**BALTIMORE COUNTY, MARYLAND
DEPARTMENT OF PUBLIC WORKS AND TRANSPORTATION
DIVISION OF CONSTRUCTION CONTRACTS ADMINISTRATION
111 WEST CHESAPEAKE AVENUE
TOWSON, MARYLAND 21204**

Contract No. 25010 PO0
Project No's. 107011861
Jacksonville Senior Center Expansion -
3605 Sweet Air Road, Phoenix, Maryland 21131
Phoenix – District 10c3

ADDENDUM NO. 1

DATE: 8/8/2025

SHEET DESIGNATION	CONTRACT NUMBER
SW203	25010 P00
	JOB ORDER NUMBER 10-701-1861 SHEET 191 OF 195 DRAWING NUMBER 2025-0408 FILE NO.: 8

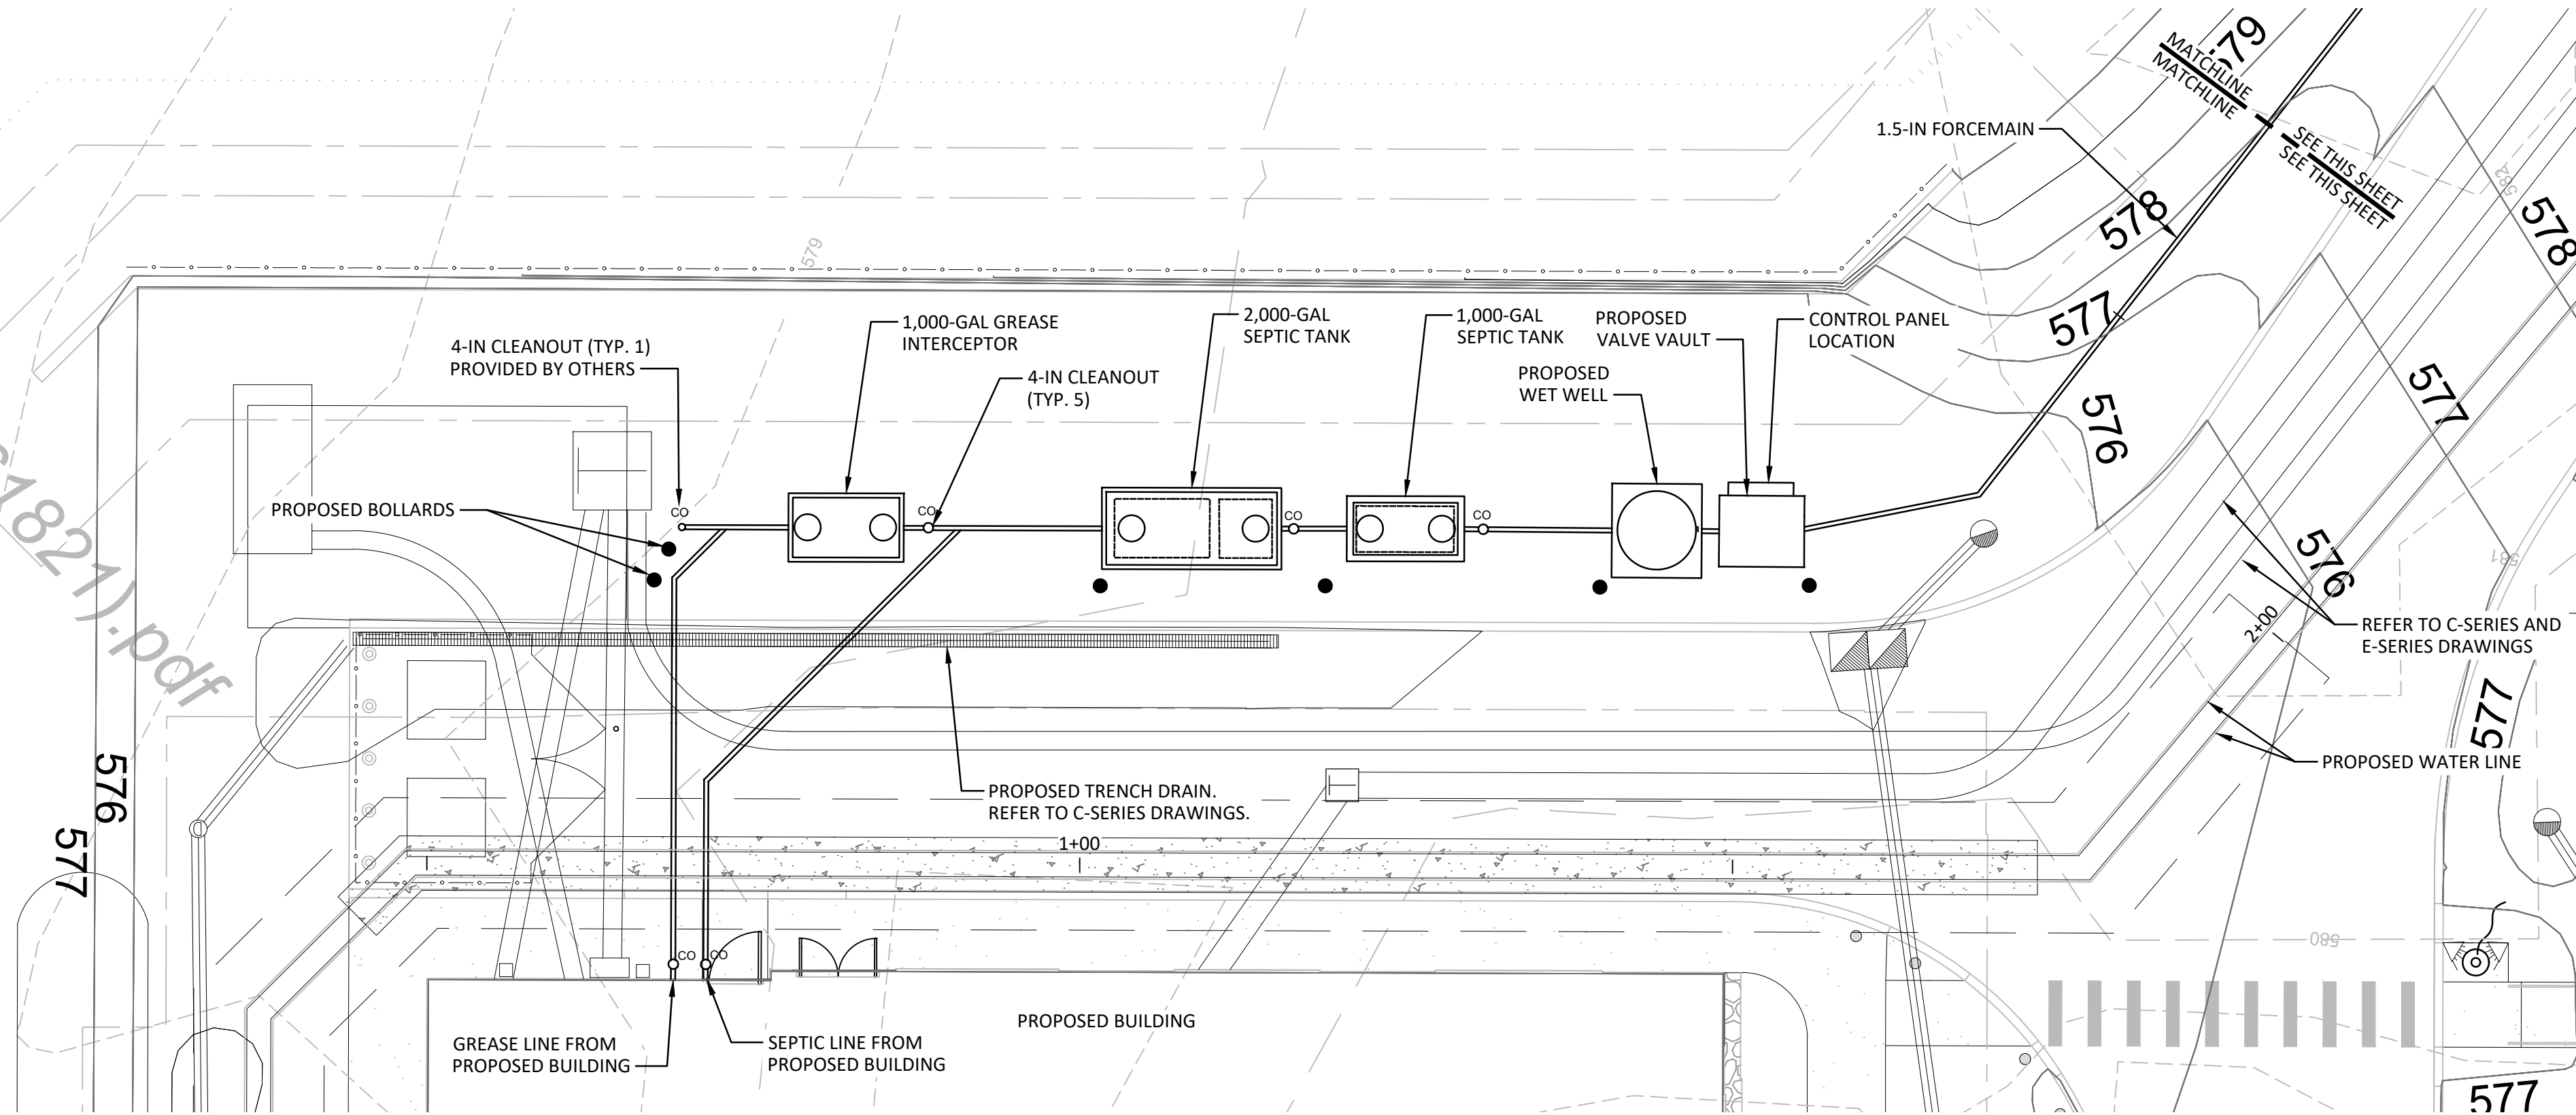
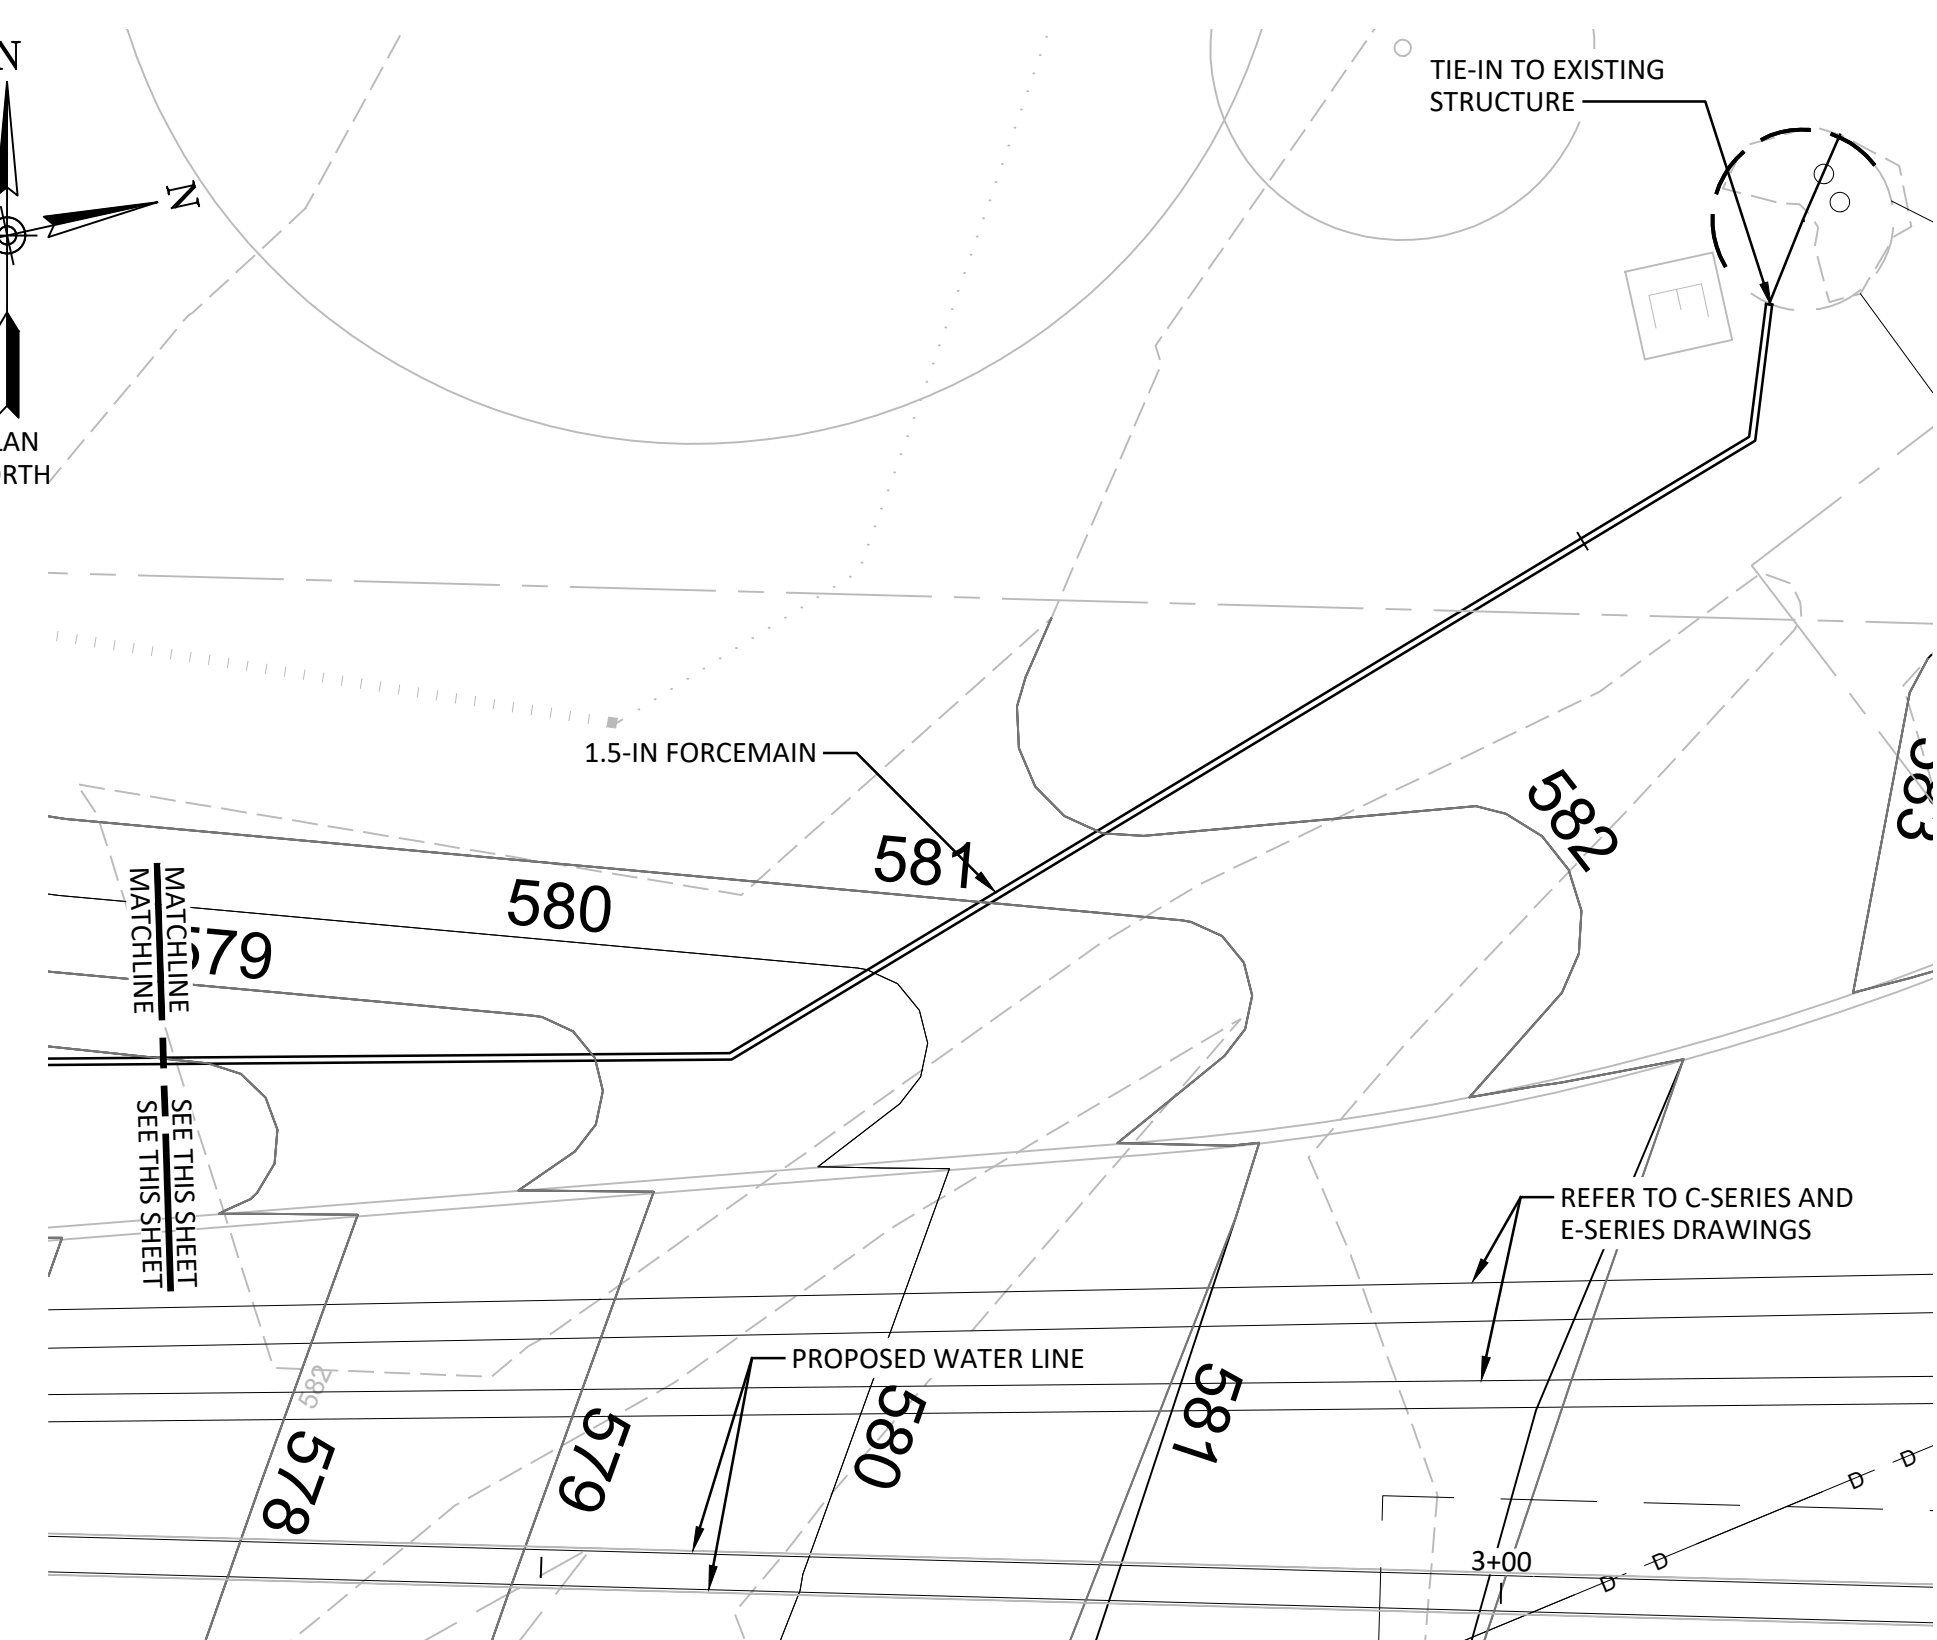
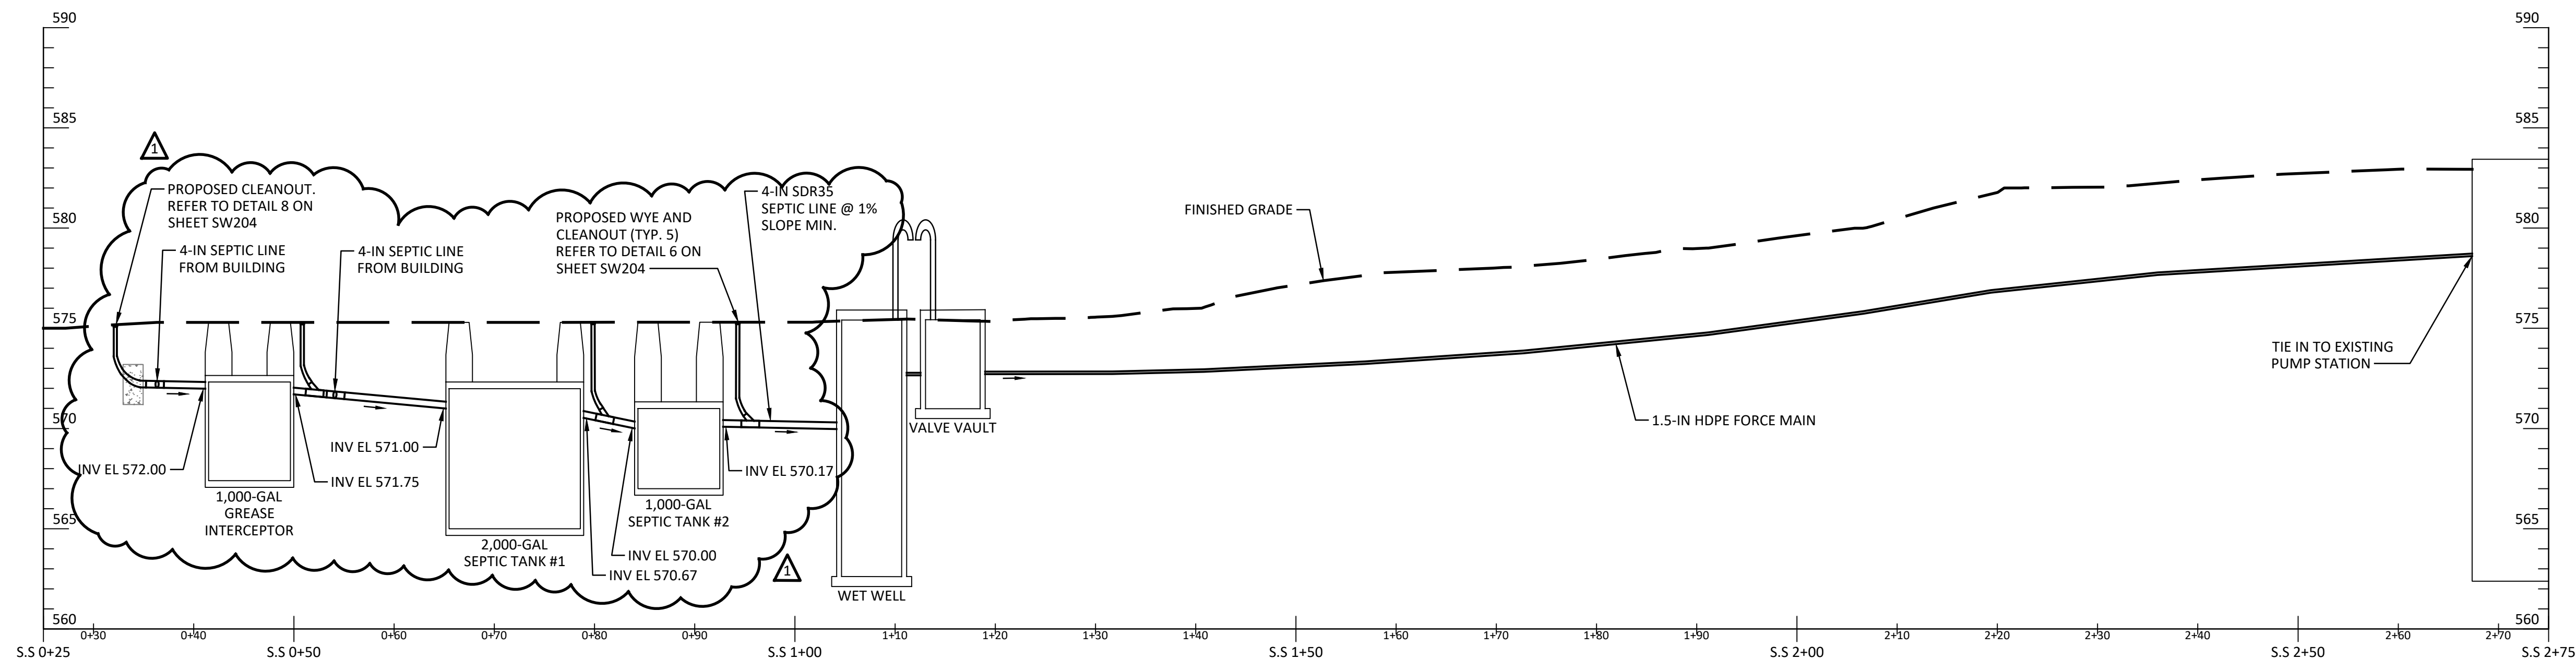
13	<p>On sheet SW202/Detail A, the finished floor elevation of the pump station is shown to be elev. 56 .00. The inlet is also shown as 56 .8. The third digit is missing in both elevations, please confirm correct elevation.</p> <p>Additionally, SW203 shows the finished floor elevation of the Pump Station to be at about 562.00 +/- . Please confirm finished floor elevation and inlet elevation of the pump station.</p>	<p>Pump Station Finished Floor Elevation = 563.00'</p> <p>Inlet Elevation is 569.8'</p>
14	<p>On the SW drawings, the invert elevation of the 4" gravity sewer coming into the pump station does not seem to match the elevations shown on the septic system profile. What is the correct invert elevation of the incoming gravity sewer into the pump station?</p>	<p>The correct inlet elevation should be 569.8'. See revised Sheet SW203 for additional elevations or schedule as shown on Sheet SW202</p>
